Planning & Zoning Board Meeting

- 2.** Consideration and Recommendation: **Venezia Townhomes Final Subdivision Plan Review**

TO: Howey-in-the-Hills Planning Board
CC: J. Brock, Town Clerk, S. O'Keefe, Town Administrator
FROM: Thomas Harowski, AICP, Planning Consultant
SUBJECT: Venezia Townhomes Final Subdivision Plat
DATE: January 20, 2022

TO: Howey-in-the-Hills Development Review Committee
CC: J. Brock, Town Clerk; S. O'Keefe, Town Administrator
FROM: Thomas Harowski, AICP, Planning Consultant
SUBJECT: Venezia Townhomes Final Subdivision Plan
DATE: January 4, 2022

C912

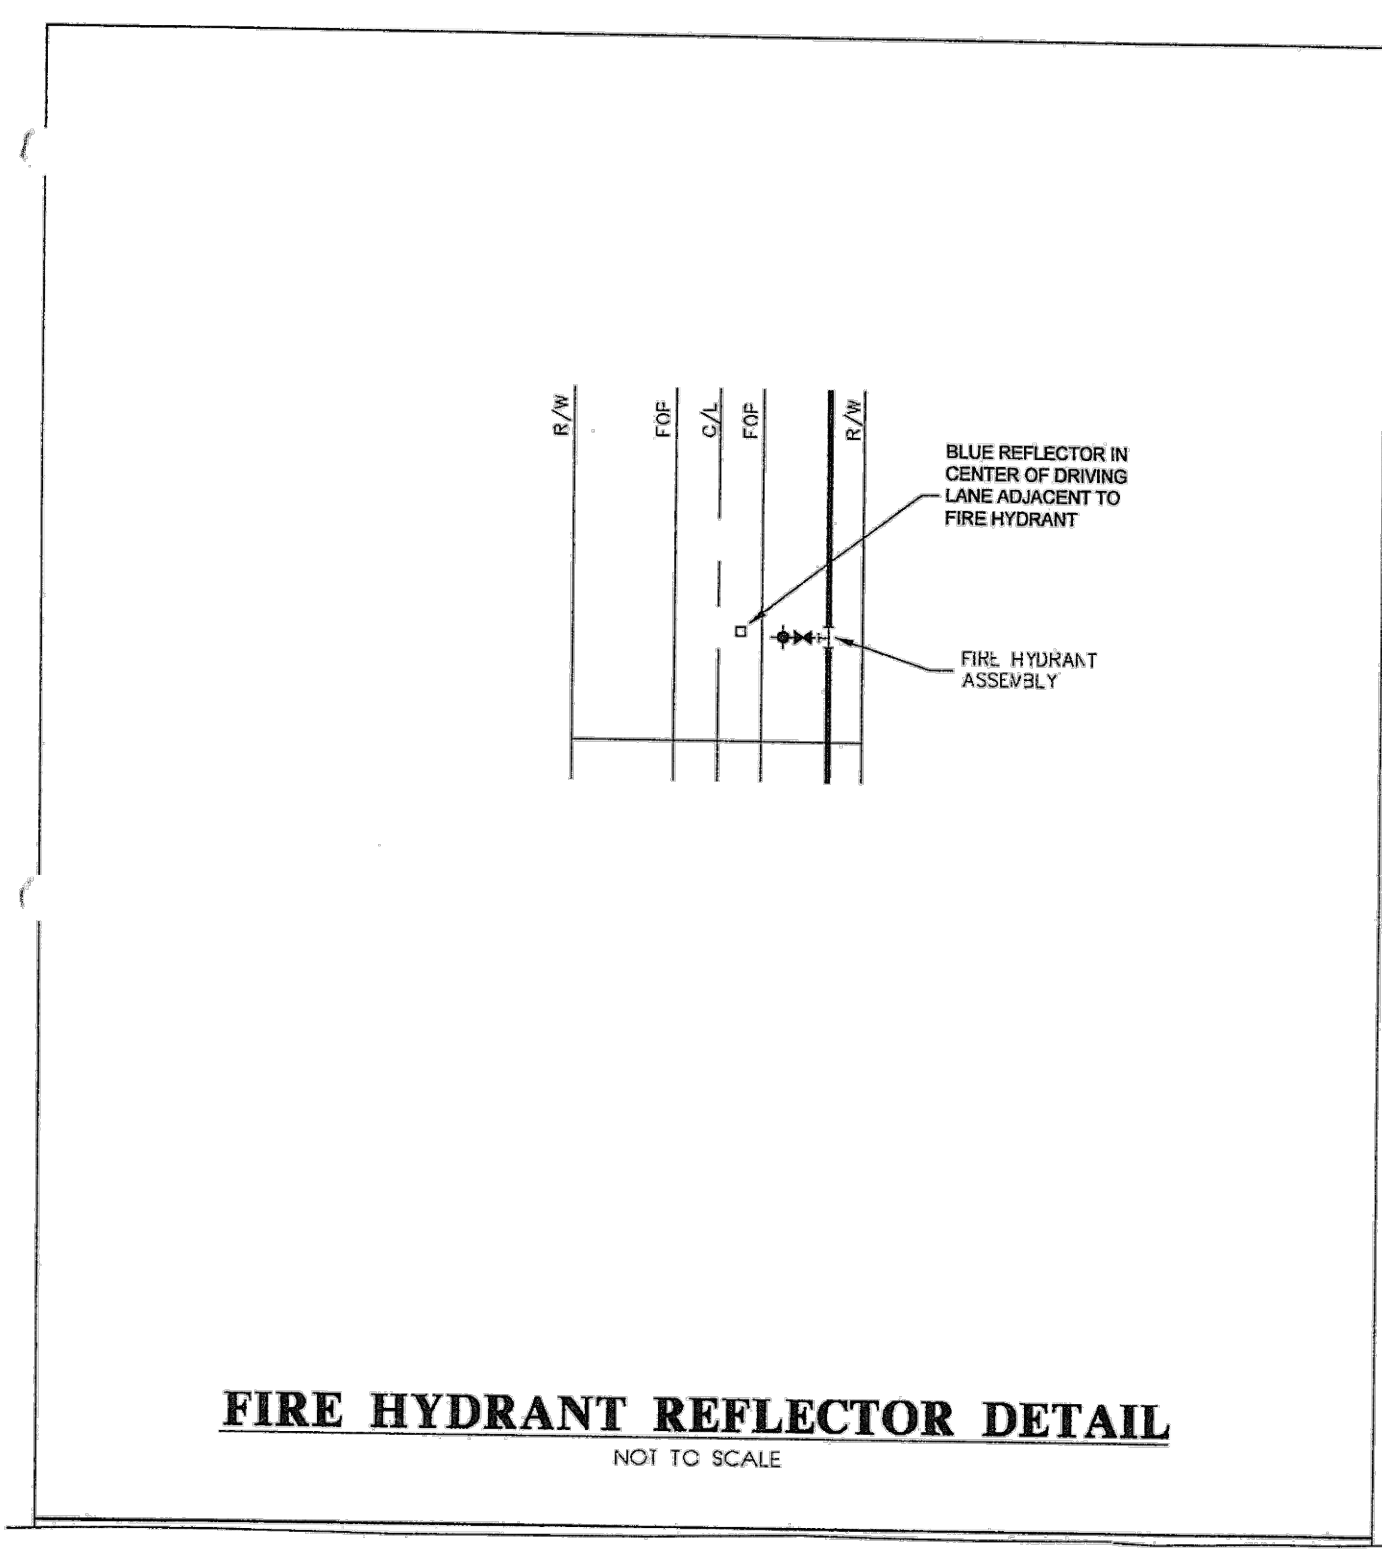
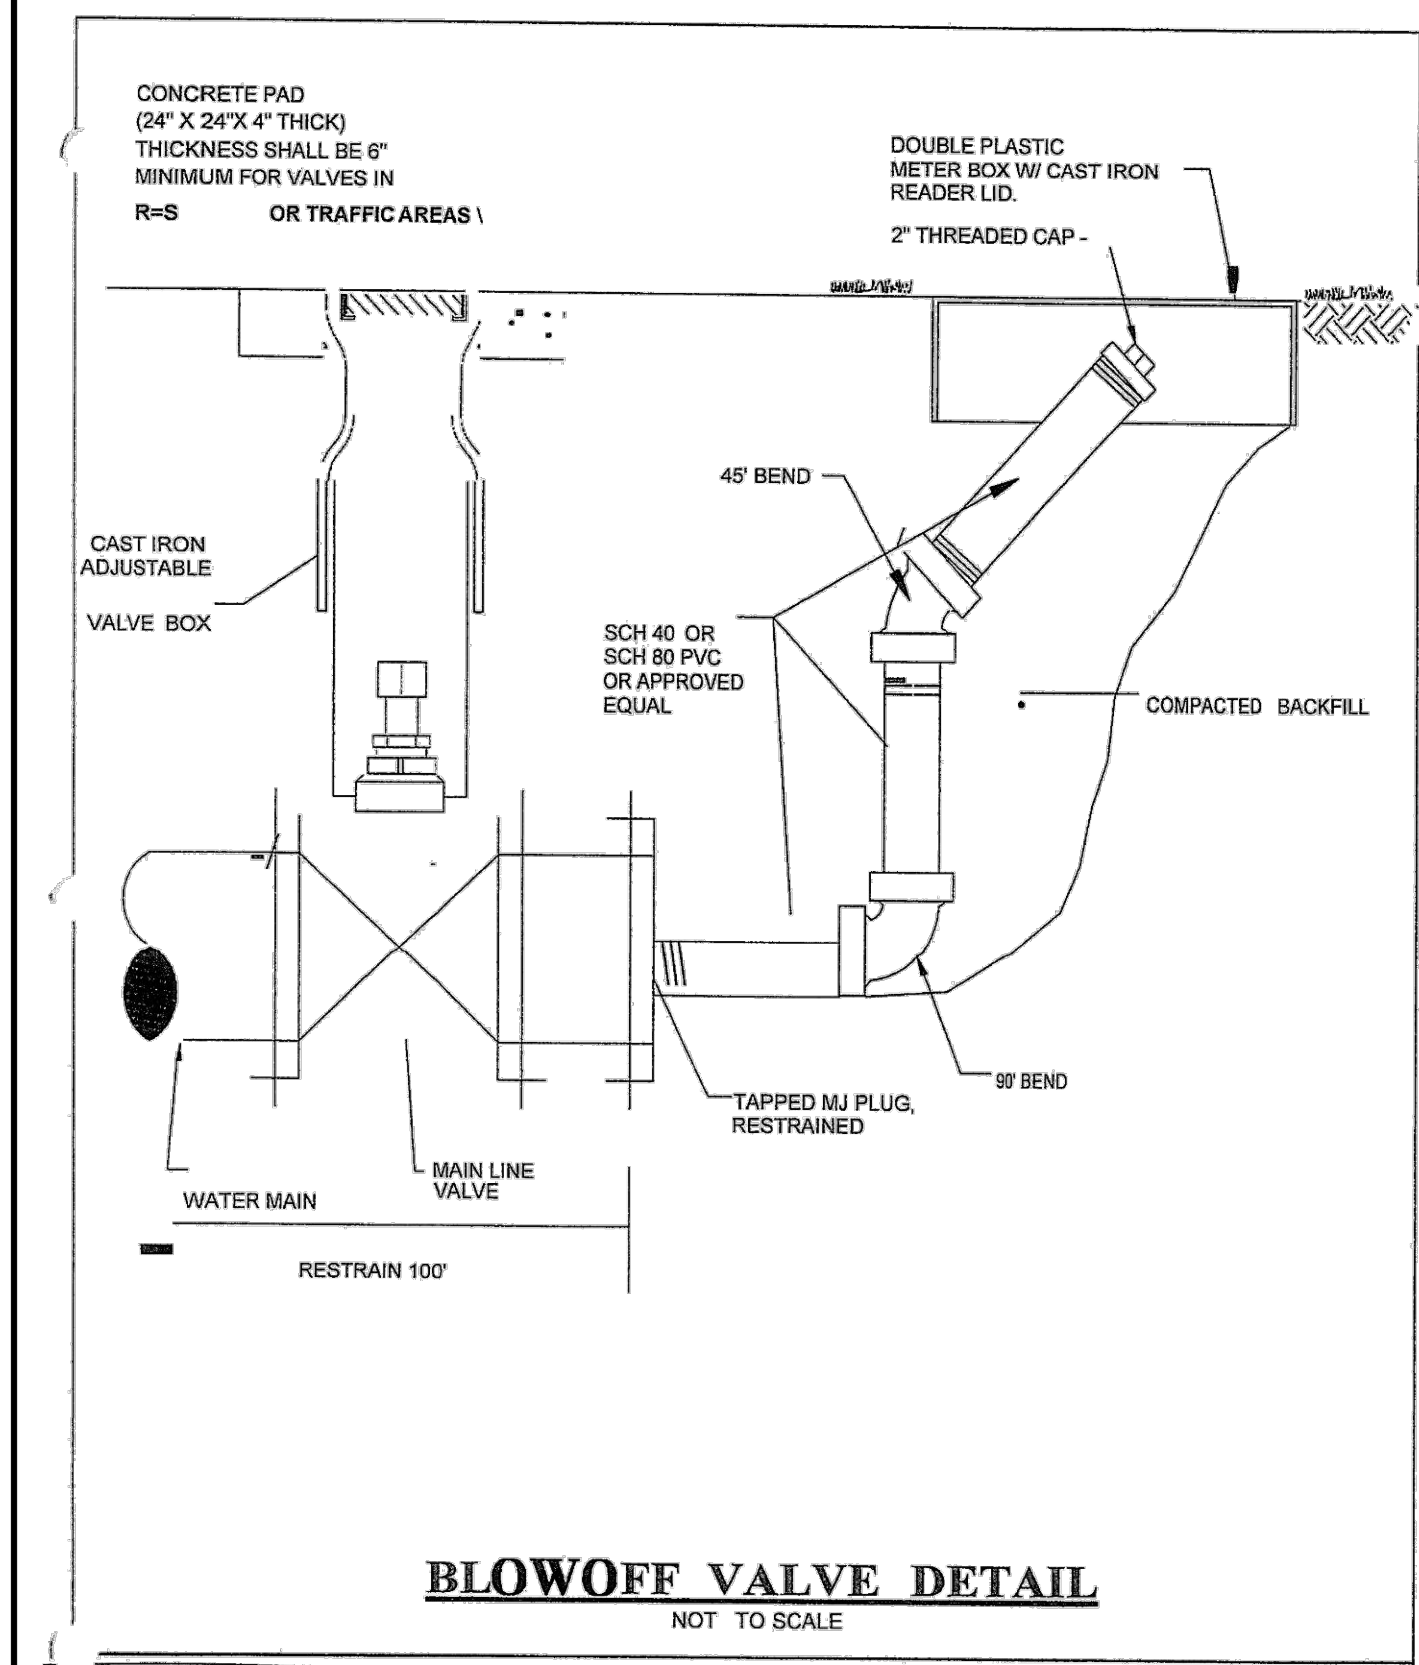
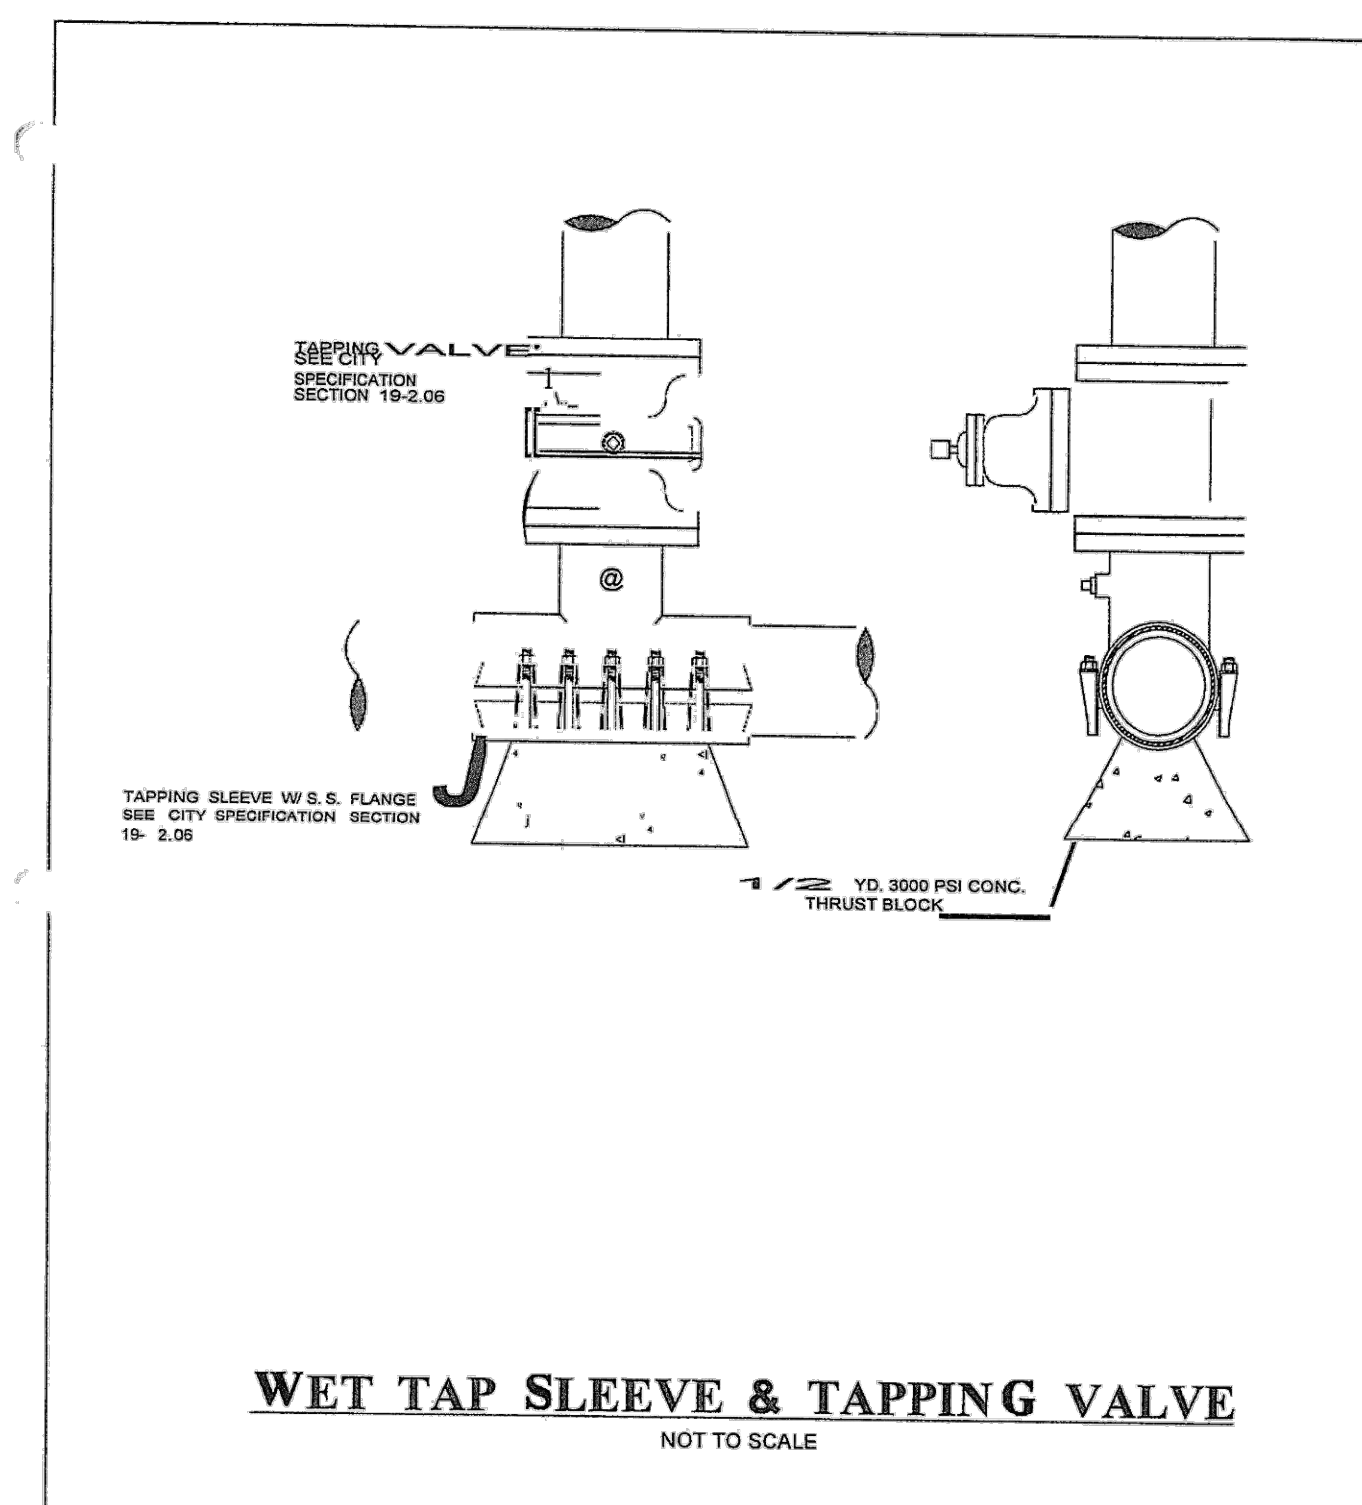
Comment 5: Provide a detail for an outside drop connection. Be sure that it includes directions to rework the paved inverts inside the manholes.

Response: Please see added drop manhole connection detail on Sheet C912.
